Item 8 - Correspondence

Re: Woodward High School Expansion Project—Phase 2

Woodward High School – Phase 2 Mandatory Referral No. MR2023017 Forest Conservation Plan No. F20230360

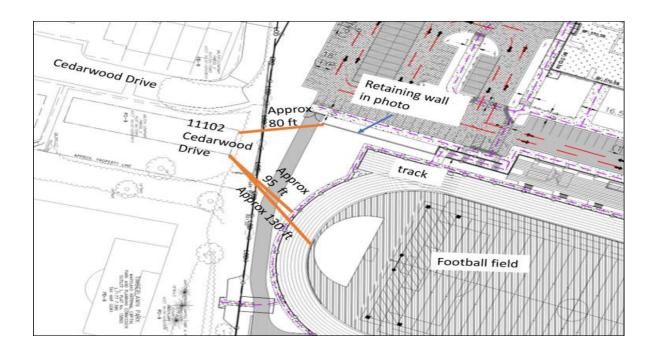
The image below, which was provided by the Montgomery County Planning Department, shows the proximity of Woodward High School (distance), and particularly the stadium, to our community. It provides a valuable frame of reference for considering the issues we face and the impact of the development on our community. In particular, our homes sit within 100 feet of the planned stadium.

Because of the close proximity of the stadium to neighboring homes, at a minimum, noise reduction designs must be implemented (and, as discussed further below, limitations imposed on school-use and community use of the athletic fields). Options to reduce noise do exist. These may include noise reducing barriers, sound blankets, and other concepts such as roofs for bleacher seats.
